Regulation No. 110 (CNG vehicles)

Proposal for amendments to ECE/TRANS/WP.29/2013/101: draft Supplement 1 to the 01 series of amendments to Regulation No. 110 (CNG vehicles)

Submitted by the expert from the Netherlands*

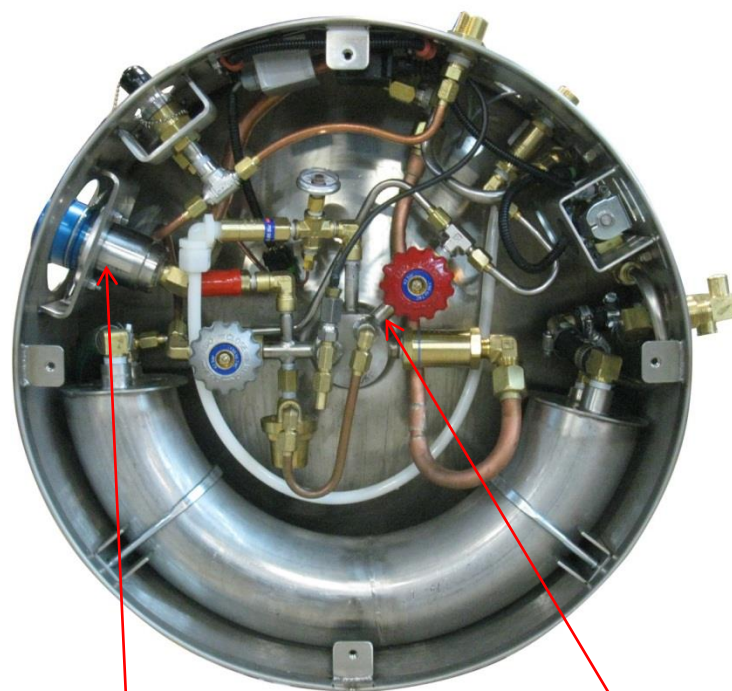
2. For LNG equipment, special care shall be taken to prevent LNG trapping. This can happen in case the automatic valve and manual valve are placed in series without taking any precautions.

"8.13.1. The LNG tank shall be equipped at least with the following components, which may be either separate or combined (**special care shall be taken to prevent LNG trapping**):

The manual fuel shut off valve shall be mounted directly on the LNG tank (in a protected position). It should be readily accessible. **The manual fuel shut off valve can be integrated into the automatic valve.**"
